WM-10
PDR

As a follow-up of an April 16 telephone conversation between RHO's Arnett and LaRue and NRC's Prestholt, Quinn and Wright I enclose two copies of pages from an NRC draft document. Page 8 discusses perceived differences between RHO's conceptual and mathematical groundwater models. Pages to 43 discuss perceived differences between RHO and PNL groundwater models.

Comparison of Boundary Conditions

Figure 2. Pasco Basin Conceptual Groundwater Flow - RHO
(After, RHO- BWI-LD-44)

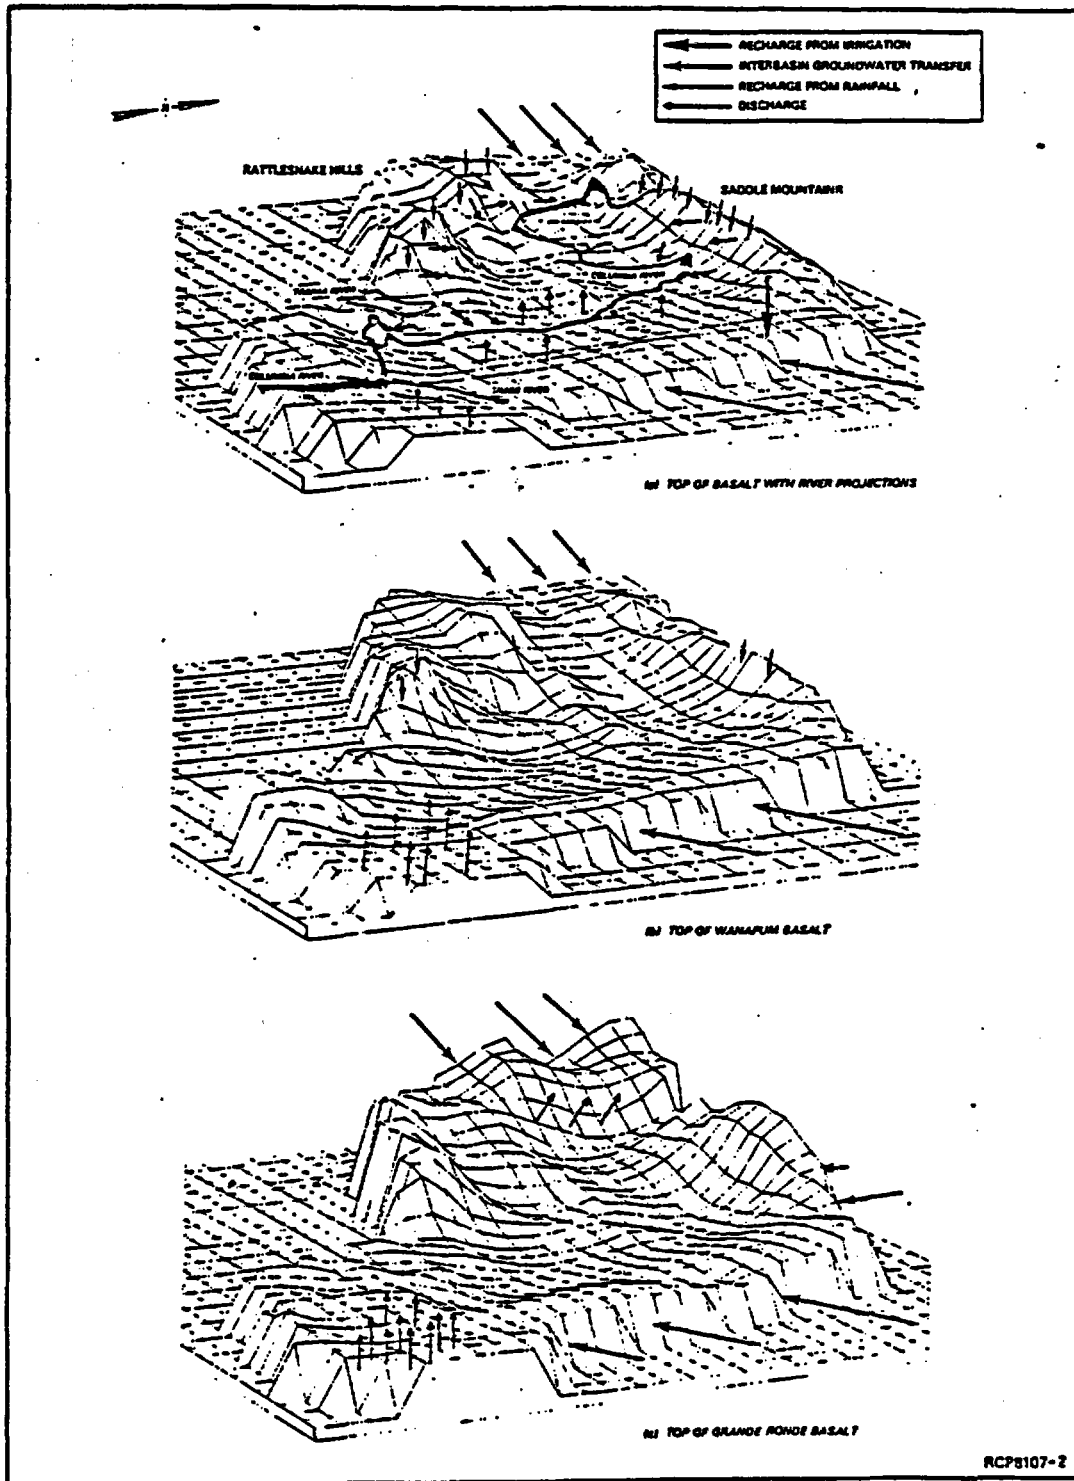
Discharge is occurring:

- 1) to the Columbia River in the top layer;
- 2) at the southeast corner (Wallula Gap area) in all layers; and
- 3) along the flanks of Rattlesnake Hills in the Grande Ronde Basalt.

Figure 24. Major Areas of Model Input Disagreement (Northwest Pasco Basin)

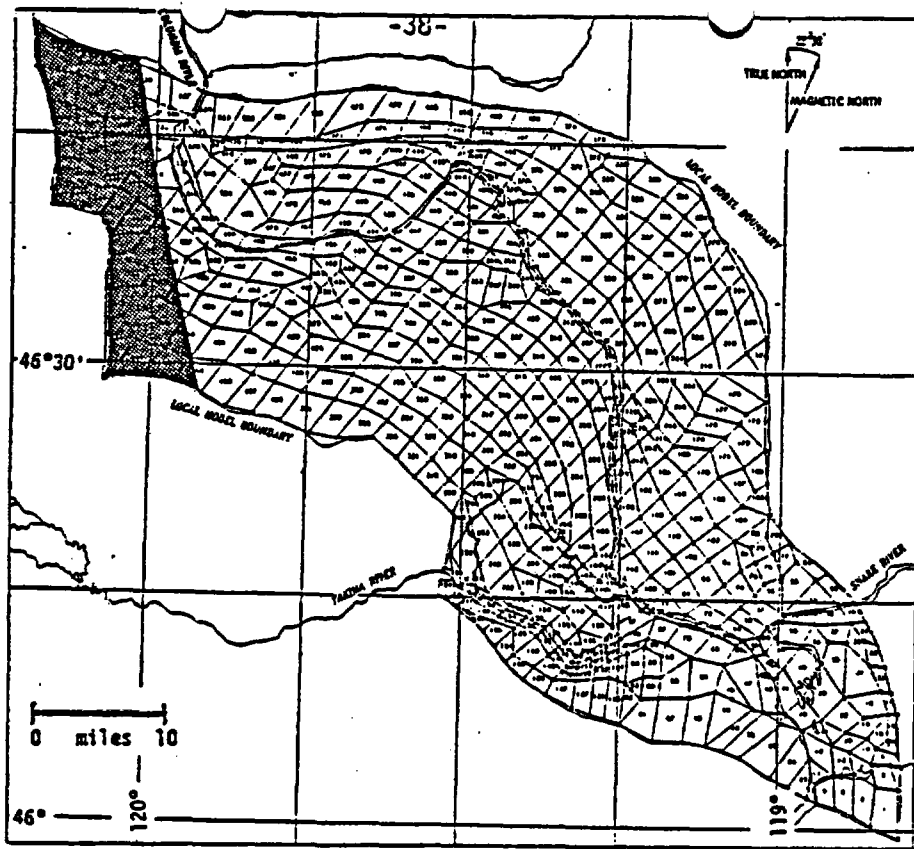
1. The Rockwell model used a recharge boundary condition along the northwest corner of the grid for approximately 25 miles. The pressure head (1,099 feet above sea level) was significantly higher than anywhere else in the model. So high, in fact, that it caused all water to flow away from this area, across the basin, and out the eastern boundary. The eastward flow of water was exactly opposite to that of PNL, who had primarily a westward and upward flow component. Figure 24.

PNL used a no flow boundary condition along the same 25 mile area, and had only small amounts of precipitation as recharge.

Figure 25. Major Areas of Model Input Disagreement (Northern Pasco Basin)

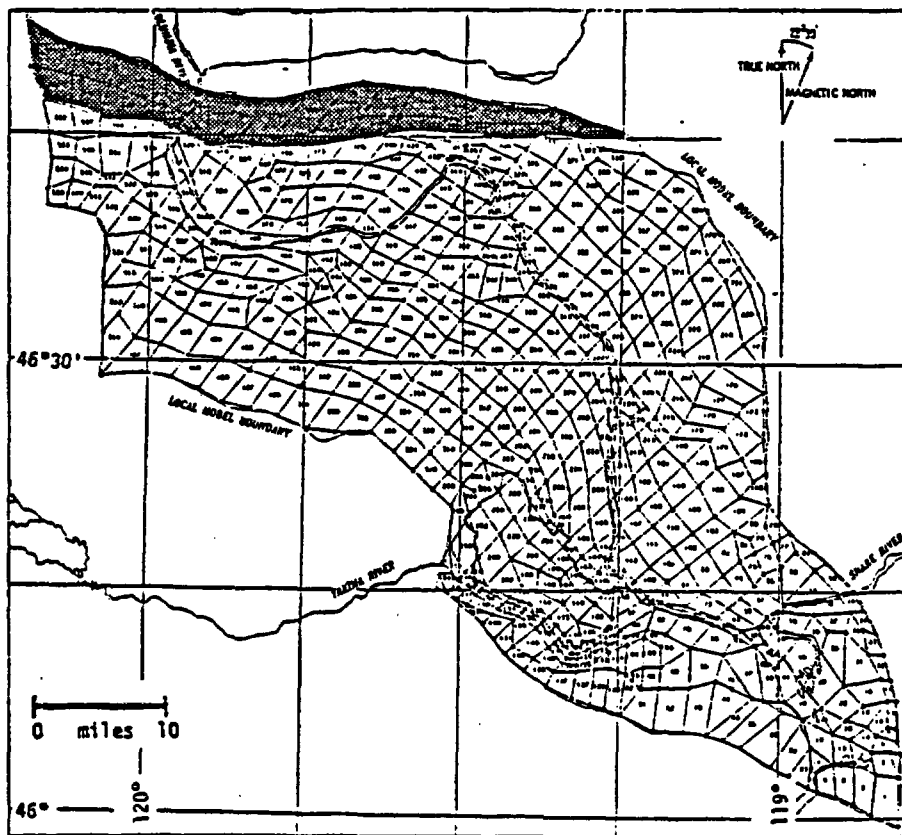
2. Rockwell set the head at the bottom of the Grande Ronde to 550 ft. above sea level for approximately 42 miles along the northern basin boundary. No flow boundaries were assigned to all units above this; thereby restricting flow from entering the basin from the north. Figure 25.

PNL assigned a flow boundary along this same area. Head values ranged from 675 to 880 ft. above sea level - increasing to the east. No-flow boundaries were assigned to the Saddle Mountains Formation only. The head difference between the two models ranged from 125 ft to 330 ft.

Figure 26. Major Areas of Model Input Disagreement (Eastern Pasco Basin)

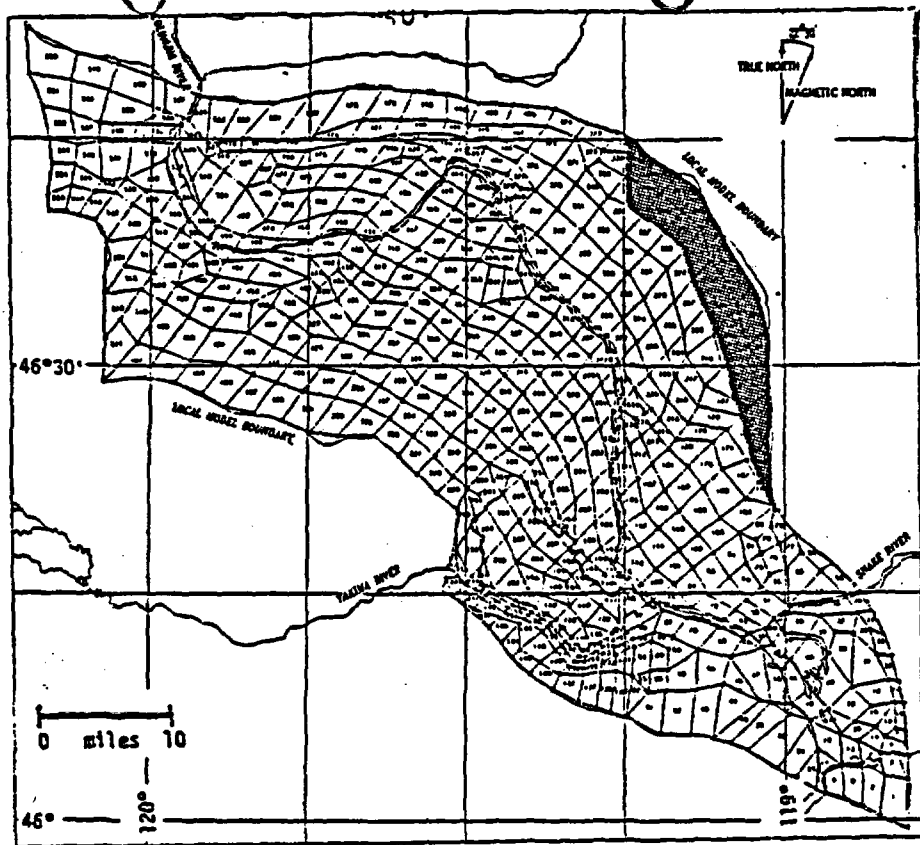
3. The eastern basin boundary of the RHO model, from the northern edge for approximately 25 miles southeastward, was set at 600 ft; and was considered to be at hydrostatic equilibrium (head constant with depth, i.e., flow is horizontal). (Figure 26).

The PNL heads along the boundary, ranged from approximately 700 ft to 1100 ft above sea level-creating a head difference that ranged from 100-500 ft between the two models. Also, the PNL boundaries were recharge areas, i.e., head decreased with depth. It should be noted that in the PNL model the highest heads occurred in this area.

Figure 27. Major Areas of Model Input Disagreement (Southeastern Pasco Basin)

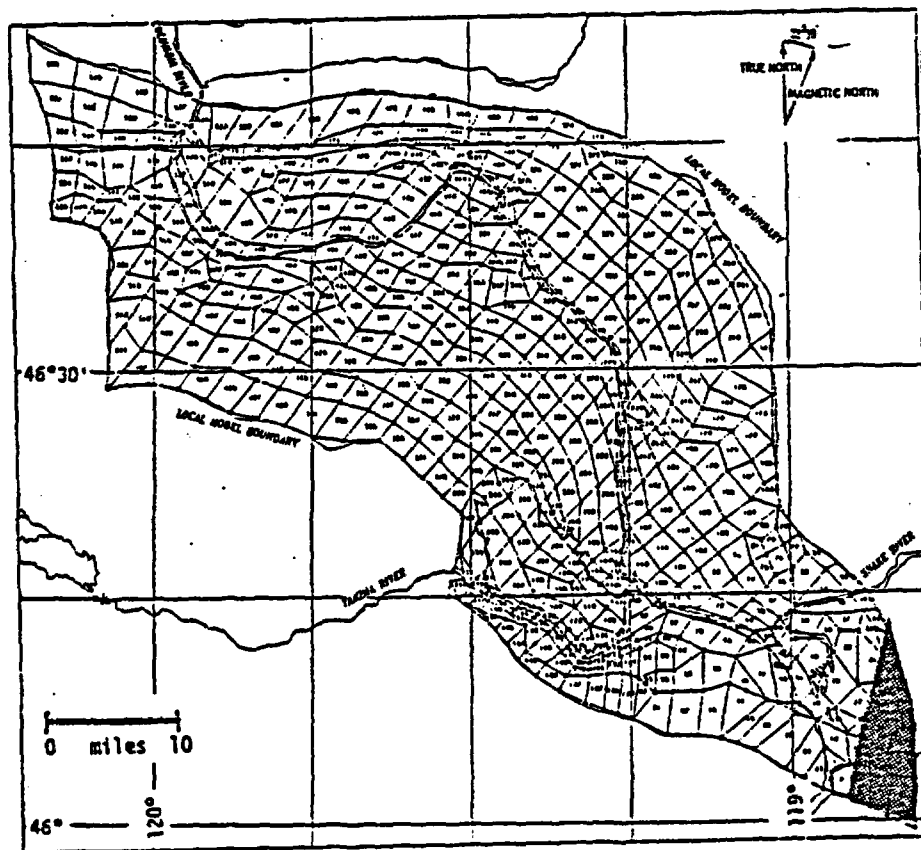
4. In the RHO model, for approximately 12 miles along the southeastern corner to Wallula Gap, heads were set at approximately 400 ft, again with the hydrostatic equilibrium assumption. (Figure 27).

In the PNL model this area was a discharge boundary with heads in the lower units set at 650 feet and at the upper units 437 ft.

The head differences between the two models result in a discrepancy of approximately 250 ft in the lower units. Since the RHO model does not permit an upward gradient in this area, no upward discharge can exist. This is significant to RHO's conclusion that particles do not leave the Grande Ronde formation.

Figure 28. Major Areas of Model Input Disagreement (Southwestern Pasco Basin)

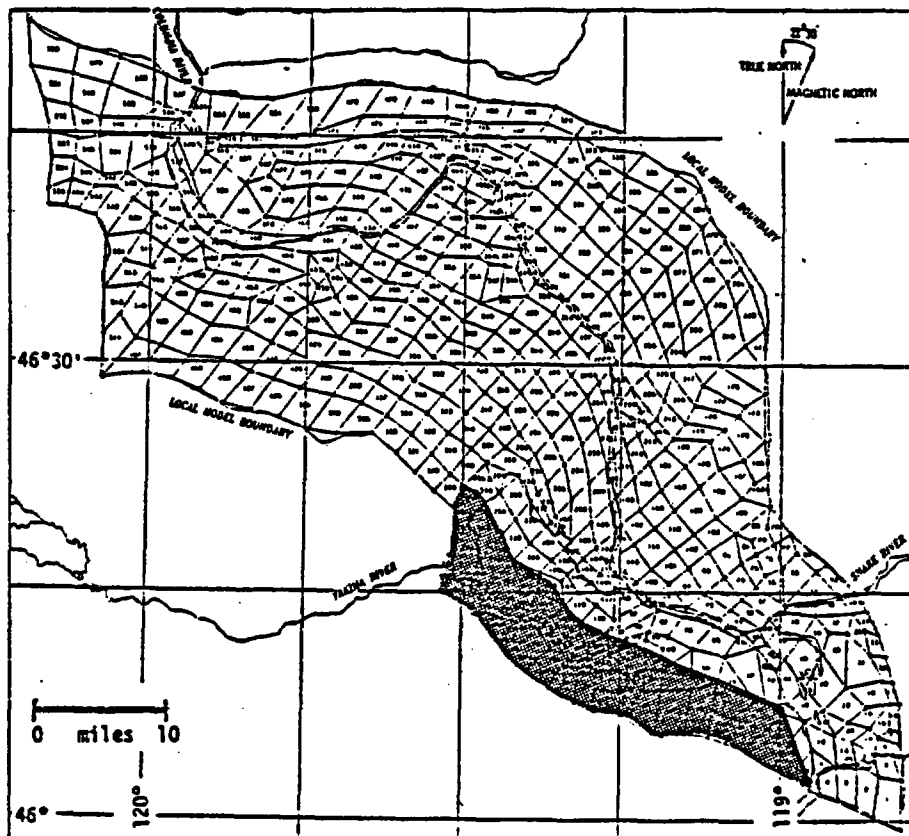
5. In the RHO model, in the area beginning just west of Wallula Gap and continuing clockwise around the southwestern boundary for approximately 30 miles, a recharge boundary condition was imposed. Heads in this area drop from 700 ft in the upper units to 500 ft in the lower units. This created a significant downward gradient, which was strong enough to be felt across the entire width of the basin (approximately 24 miles). The recharge effect forced water downward in the Wallula Gap area, instead of upward as would be expected in a discharge area. (Figure 28).

The PNL model assumed a no flow boundary condition along this same stretch.

Figure 29. Major Areas of Model Agreement (Western Pasco Basin)

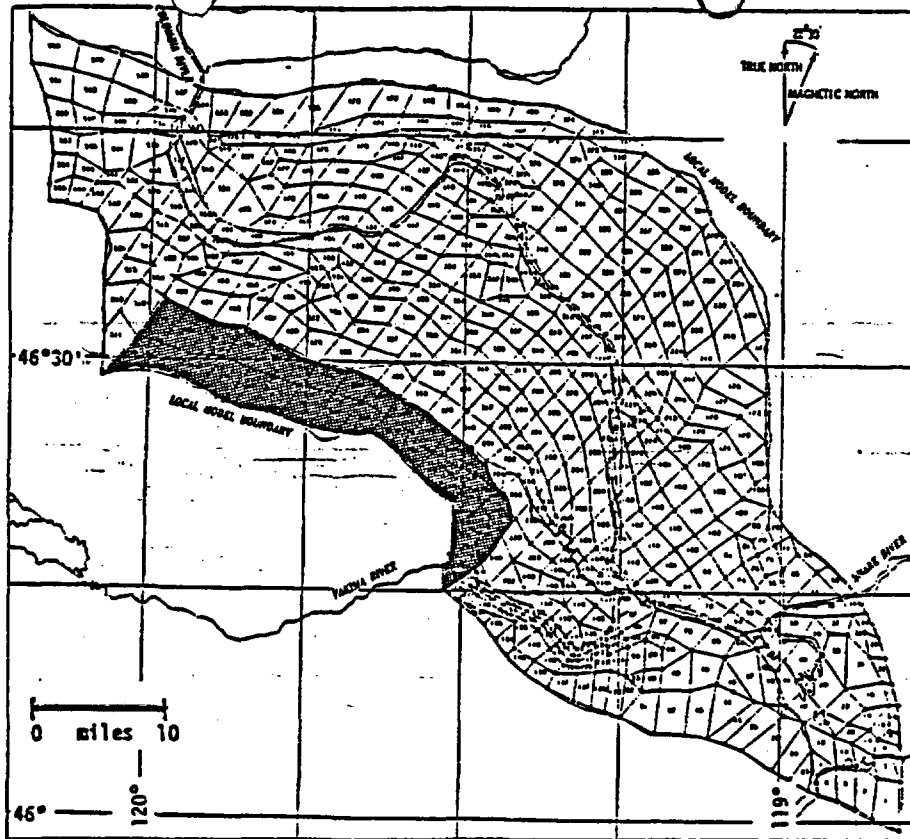
1. Water table surfaces were very similar and were both forced by use of constant head pressures in both models.
2. River elevations were approximately the same in both simulations.
3. In the area of Rattlesnake Hills, both models had essentially a no flow boundary condition. (Figure 29).
4. In the area surrounding the Snake River (for approximately 12 miles) both models had discharge boundary conditions. (Figure 30).
